Homestake Mining Company of California
P.O. Box 98
Grants, NM 87020

**RE: Response to Request for Additional Information, Corrective Action Report,
Unauthorized Discharge from Off-site Well, DP-200, Homestake Mining
Company**

SUBJECT: U.S. NUCLEAR REGULATORY COMMISSION REVIEW OF HOMESTAKE MINING COMPANY OF CALIFORNIA CORRECTIVE ACTION REPORT FOR THE UNAUTHORIZED DISCHARGE FROM OFF-SITE WELL [WELL 490], MATERIALS LICENSE SUA-1471, DOCKET NUMBER 040-08903

Figure 1: Gamma radiation survey results, expressed as exposure rate ($\mu\text{R/hr}$). The location of Well 490, the estimated spill affected area, and locations of three soil samples collected are also shown.

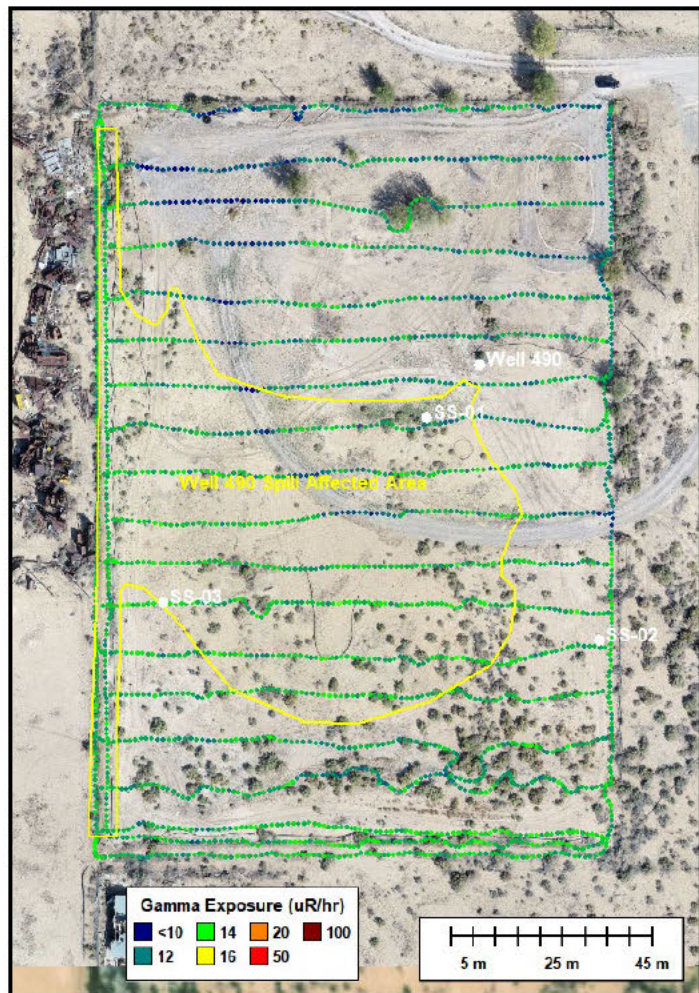
2. *The permittee shall provide a work plan to NMED for approval to conduct additional soil characterization of the affected area. Specifically, NMED requests that the permittee conduct soil sampling and analyses to verify the results of the radiological dose assessment.*

Prior to receipt of NMED's request for a work plan, Homestake initiated an assessment of the spill area, including a GPS-based gamma radiation survey and soil sampling. Enclosed with this correspondence is the ERG assessment, which notes that the total U-nat concentration in the soil samples collected are well below the EPA's 16 mg/kg Regional Screen Level for uranium in residential soils based on toxicological health considerations and are within the range of background concentrations previously exhibited in soil samples collected on HMC property in the area.

The gamma data suggest that imported material has been applied as road base to the surfaces of roadways within the lot, resulting in lower gamma exposure rates in these locations due to shielding of photon emissions from underlying soils. The range of measured exposure rates across the lot are consistent with background conditions across soils within the alluvial valley in which the HMC Site is located.

The U-nat concentration measured at sample location SS-01 (near the head of the spill as shown in Figure 1) is 0.2 mg/kg higher than the U-nat at the unaffected background location (Sample location SS-02). The initial calculated estimate of the increase in soil U-nat concentrations in surface soils (0-15 cm) due to the spill was 0.16 mg/kg (HMC, 2020; ERG, 2020), suggesting that the predicted incremental increase due to the spill agrees reasonably well with the measured difference between the spill-affected area and the unaffected background location. However, given a reporting level for U-nat of 0.3 mg/kg (Table 1), and since spatial variability in background U-nat levels in unimpacted surface soils in the nearby former Section 34 land application area ranged from 0.58 to 5.85 pCi/g (0.86 to 8.6 mg/kg) (HMC, 2017), it cannot be concluded that the slightly higher U-nat result at sample location SS-01 is due to the spill. The same is true for the measured U-nat concentration at sampling location SS-03 within the spill-affected area.
